FED. ROAD DIST. NO.	STATE	FED. AID PROJ. NO.	FISCAL YEAR	SHEET NO.	TOTAL SHEETS
HAWAII	HAW.	NH-H1-1(275)	2021	ADD. 40	65

PAVEMENT GRADE PLANS

INTERSTATE ROUTE H-1 REHABILITATION
SALT LAKE BOULEVARD TO AIRPORT VIADUCT
FEDERAL-AID PROJECT NO. NH-H1-1(275)

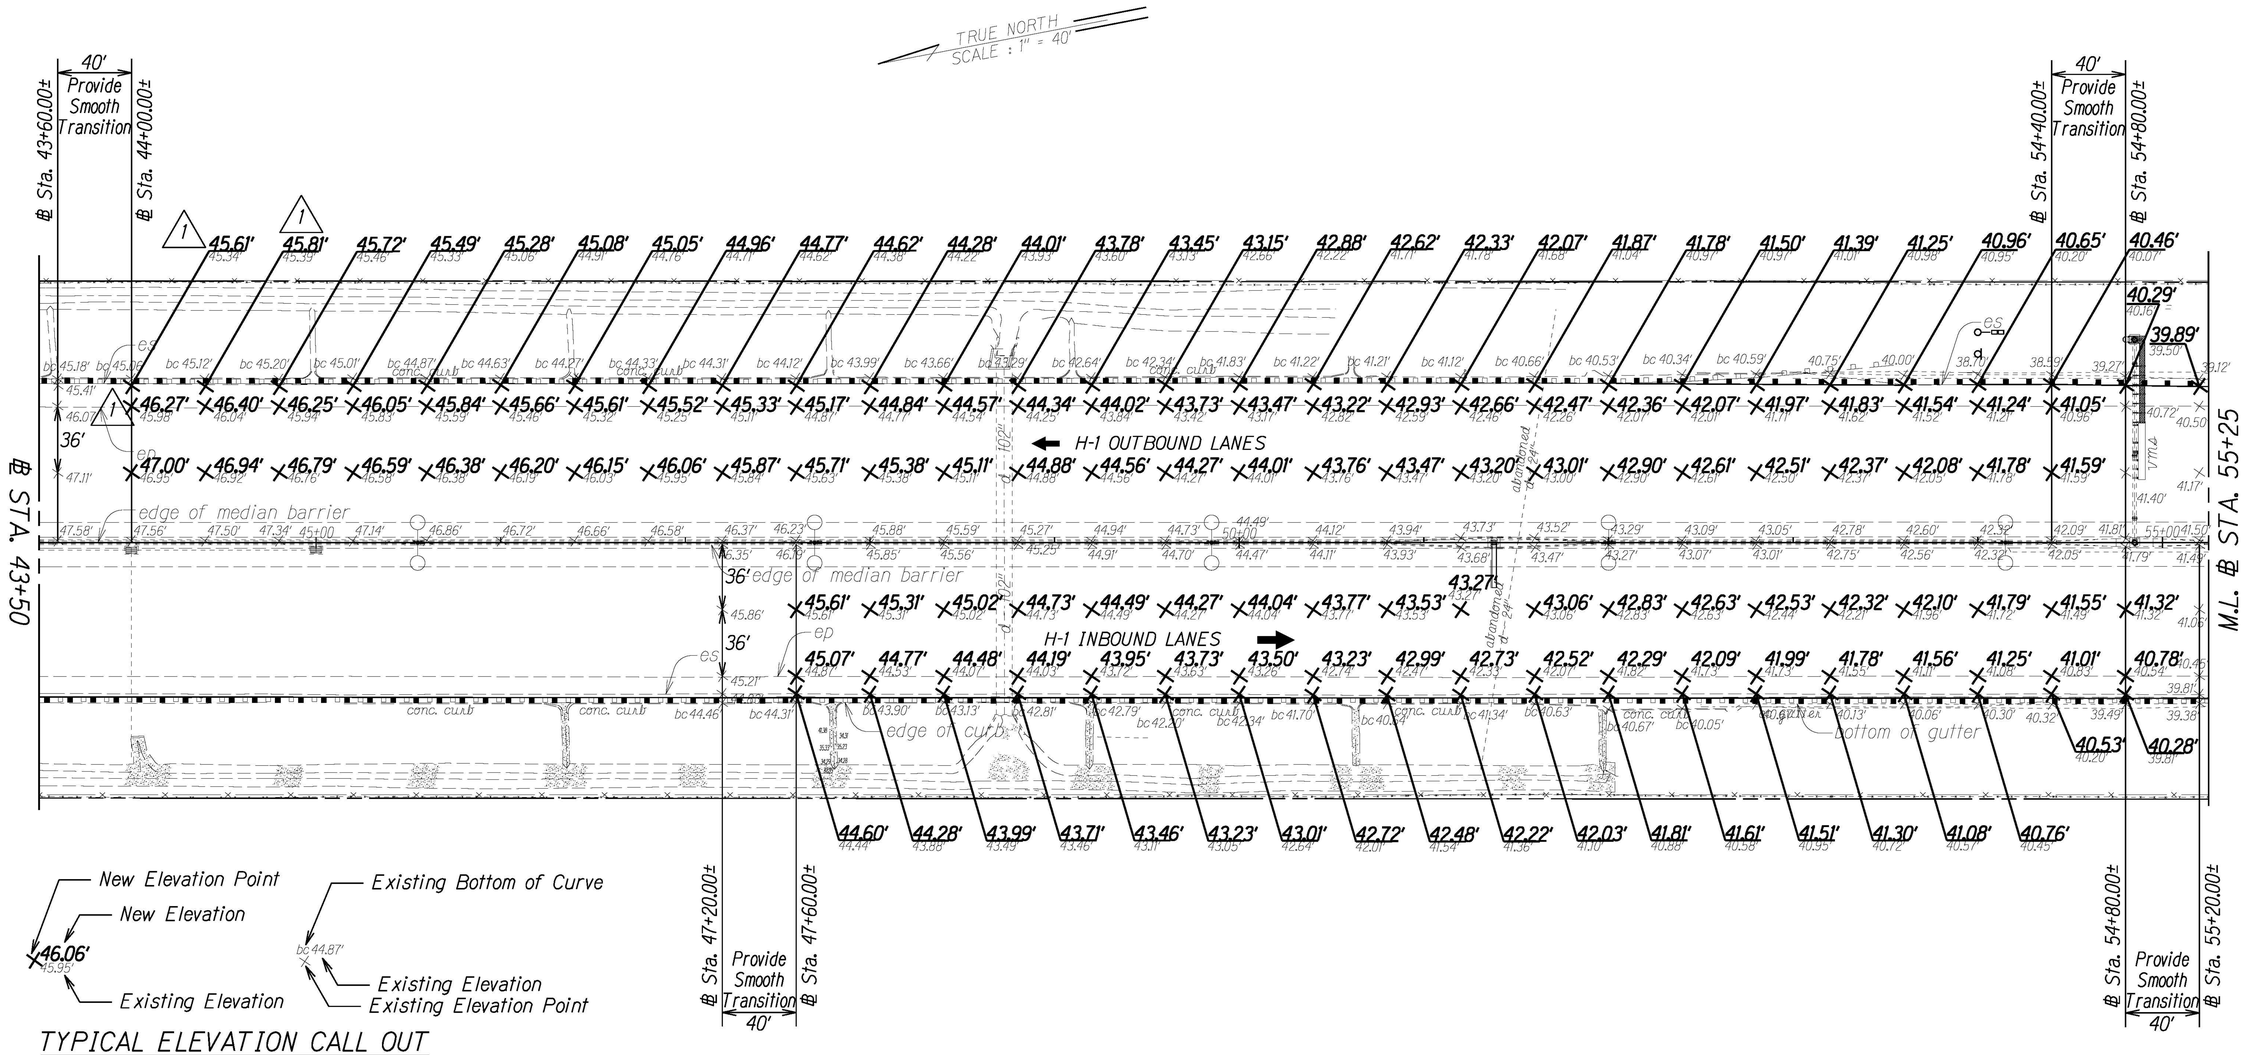
DATE	REVISION
11/10/21	Added Note 3. Revised Various New Grade Elevation Points. Added smooth transition callout at ℄ Sta. 54+40 (Outbound).

PAVEMENT GRADE PLANS

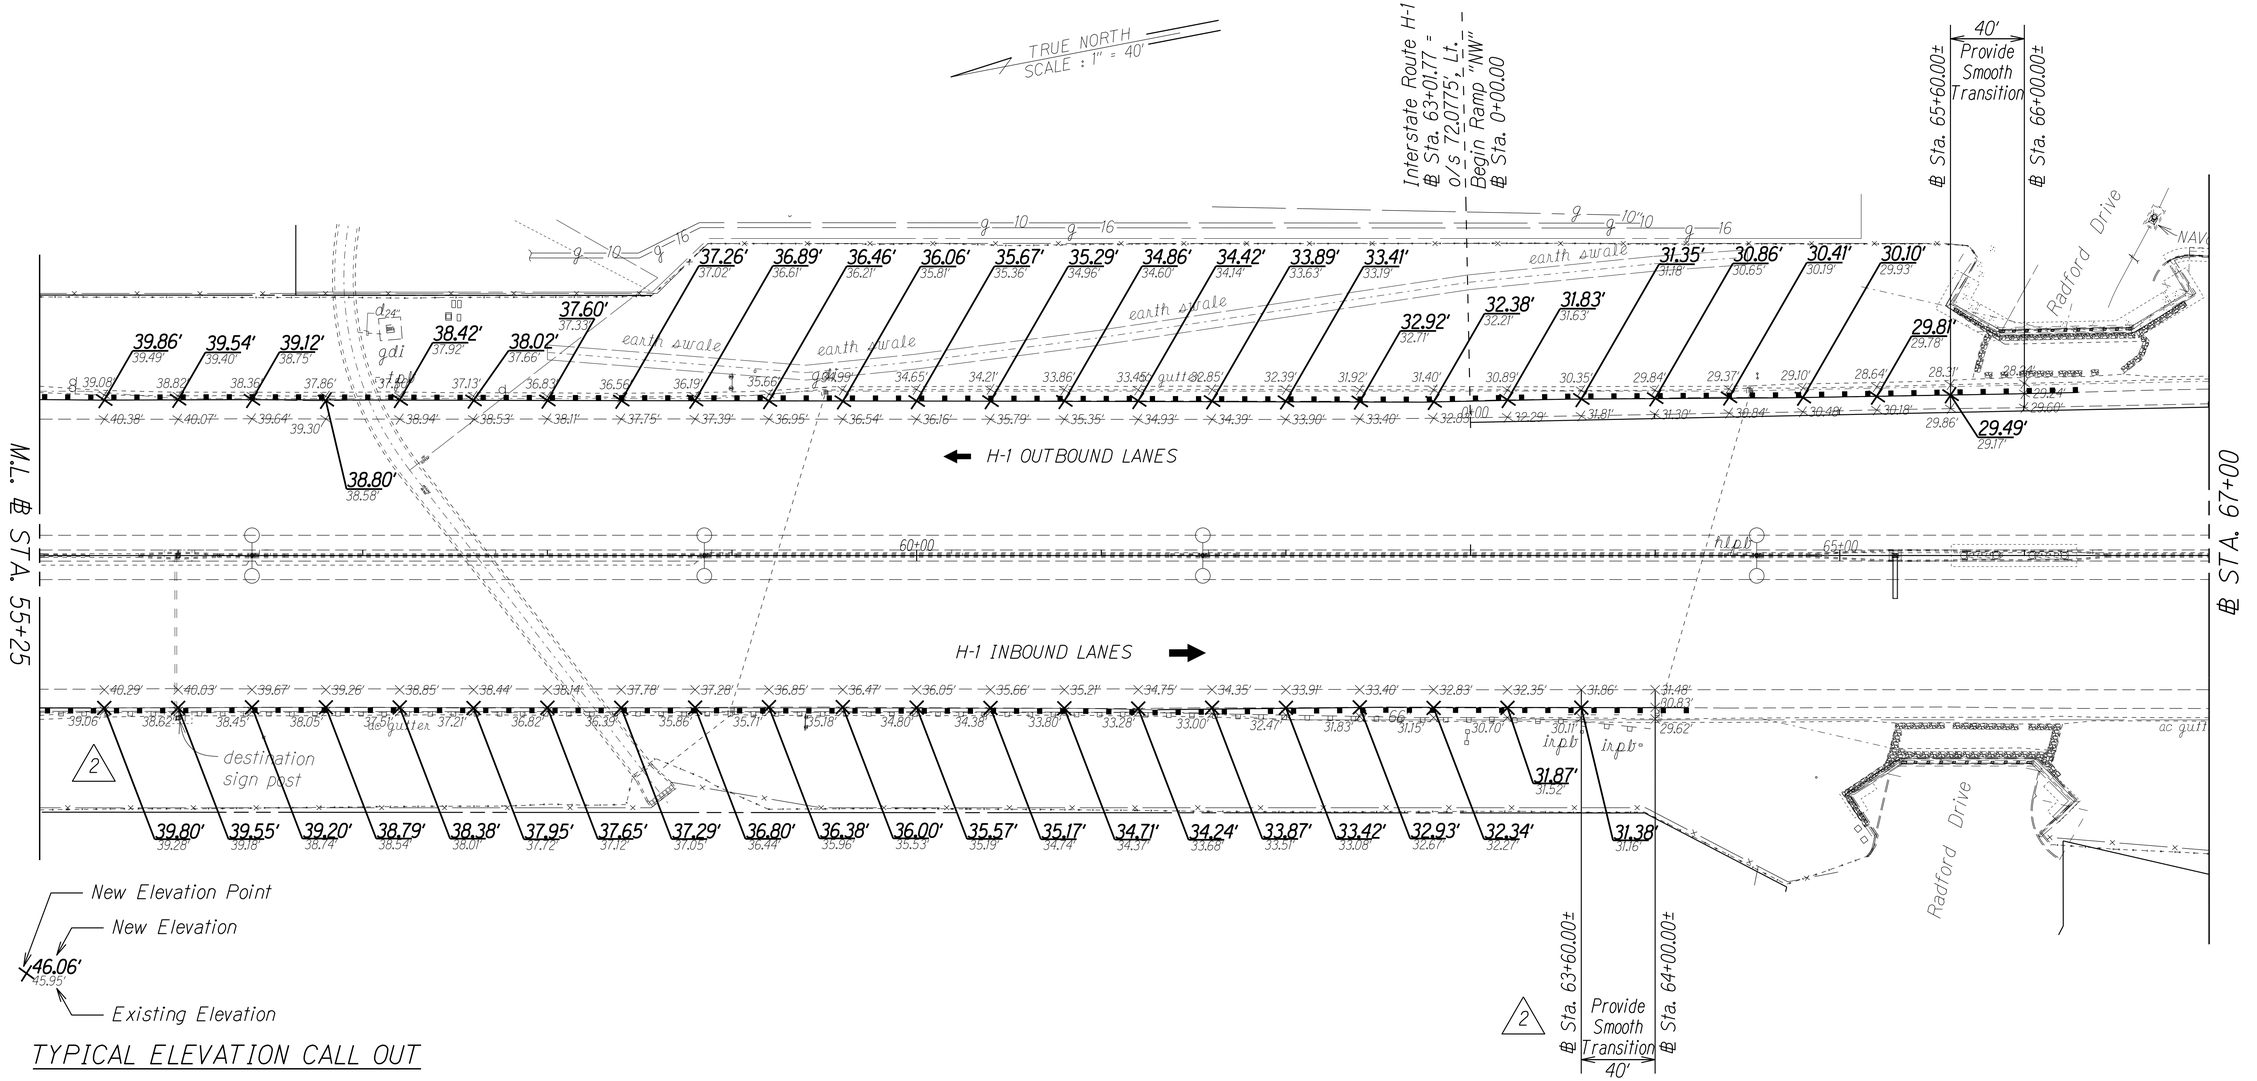
DATE	REVISION
11/30/21	Added additional grading points along inbound right shoulder.
11/10/21	Added Note 3.
